**REMARKS**

This is in response to the Office action mailed July 25, 2005.

FIG. 6

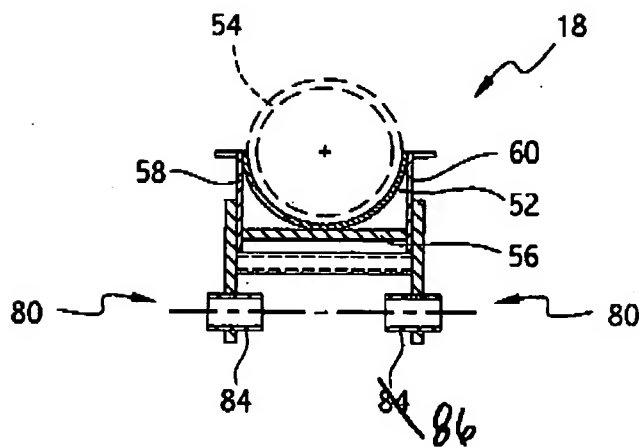
has been changed to character "44" and to Figures 3 and 6 wherein a character "84" referencing a tube has been change to character "86." Replacements sheets reflecting these amendments are also submitted herewith. In addition, applicant has amended the specification to remove all references to characters 11, 13, 95 and 97. Accordingly, withdrawal of the objection is respectfully requested.
